CERTIFICATE OF APPROPRIATENESS

Property: 1341 Cortlandt St, Lots 1 & 2, Block 169, Houston Heights Subdivision. The property includes a historic 1,849 square foot, two-story wood frame multi-family residence and two non-historic multi-family buildings situated on a 13,200 square foot (100' x 132') corner lot.

Proposal: New Construction – Construct a 152 square foot accessory building at the rear of the property.

Recommendation: Approval

NORTH ELEVATION – FRONT FACING E 14th STREET

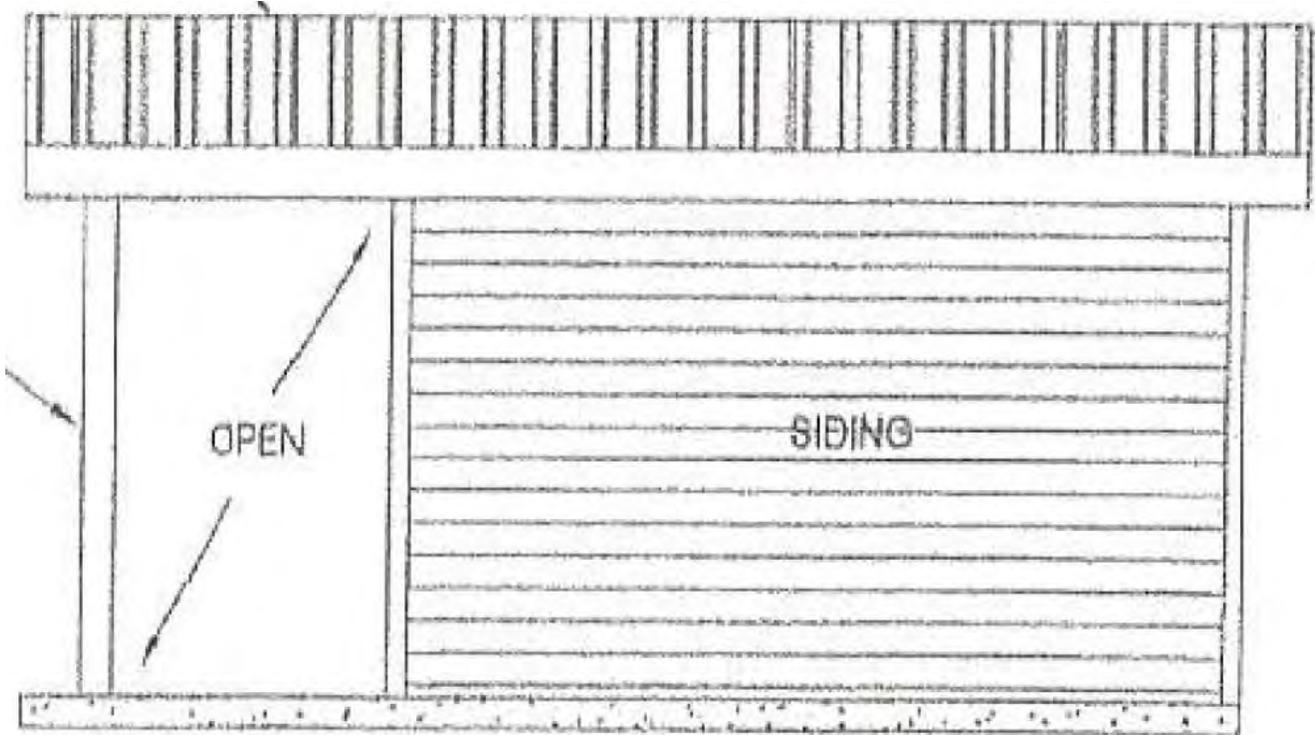
HHEHD – 1246 Columbia, no objection; 1341 Cortlandt, object, window needs to be vertically oriented to be compatible with typical district window proportions; 1515 Oxford, object, fixed windows, square windows, faux shutters, and 2nd story breezeway connection are not compatible with typical district elements.
